WALSH BAY ARTS AND CULTURAL PRECINCT

RESPONSE TO SUBMISSIONS

TZG RESPONSE TO CITY OF SYDNEY SUBMISSION

CITY OF SYDNEY

Figure 3: Proposed view from Sydney Harbour with new work highlighted blue.
Source: Mogamma 2017

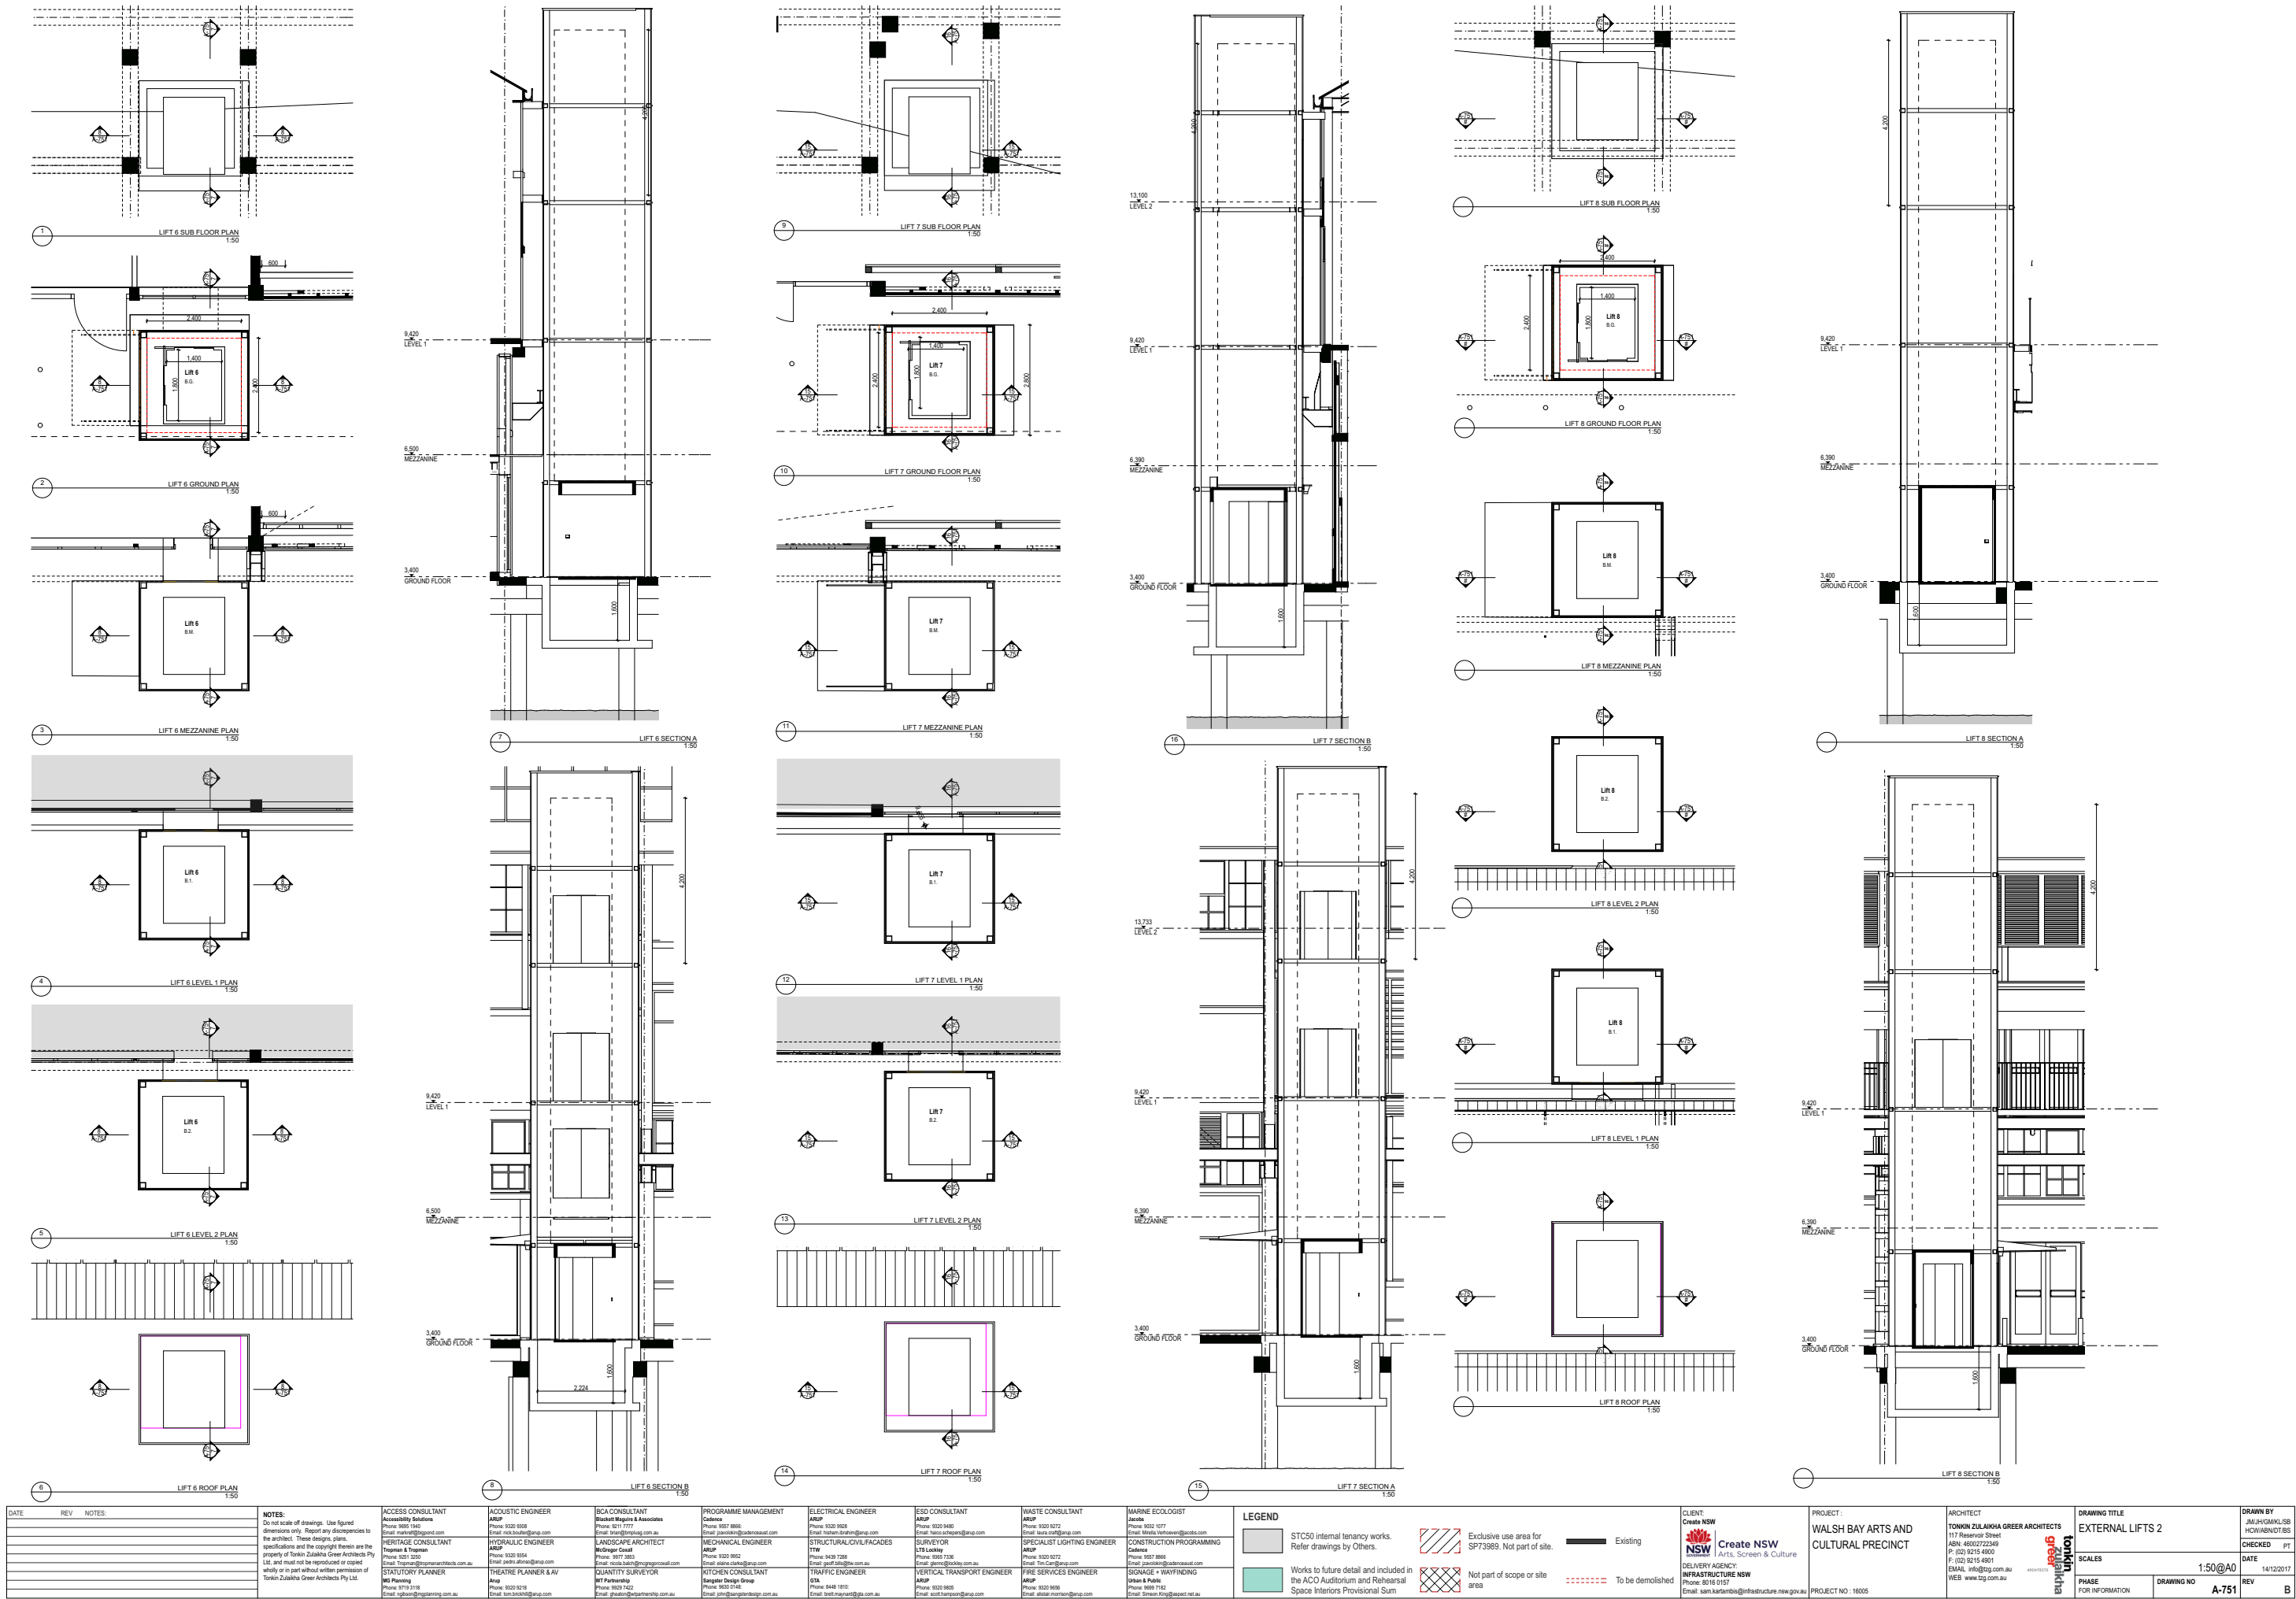
City of Sydney Comment - 1 a)
Concern is raised regarding the height of the proposed external lifts and their visual prominence from key vistas when viewed from Sydney Harbour, particularly at the northern end of Pier 2/3. Consideration should be given to a reduction in height of the lift over-runs and locating these lift shafts further south along each elevation. It is also recommended that lift shafts and balconies are aligned symmetrically on the eastern and western elevations of the wharf buildings.

Response
A sympathetic and modest design approach has been adopted for all external additions to ensure that they respect the industrial character of the wharves and to minimise their visual prominence. A similar architectural language is proposed for the new lifts, stairs and gantries for both Wharf 4/5 and Pier 2/3 to clearly distinguish new elements from original fabric, to unify the composition and ensure visual consistency across the precinct.

Locating four of the lifts external to the building minimises the impact on interior significant fabric. Their impact on the exterior has been minimised by designing them as contemporary steel framed glazed elements that are as transparent as possible and reversible.

The external lifts are set back from the wharf edge by a minimum of two structural piling bays in accordance with Policy 9.6.5 of the Pier 2/3 CMP and positioned to relate to the internal uses they serve.

The lift shafts have been designed to be as small as possible to provide equitable access and efficient goods movement within the Precinct. The height of the overall lift shaft structures has been carefully considered in terms of overrun, relationships to the original buildings and consistency within the Precinct.
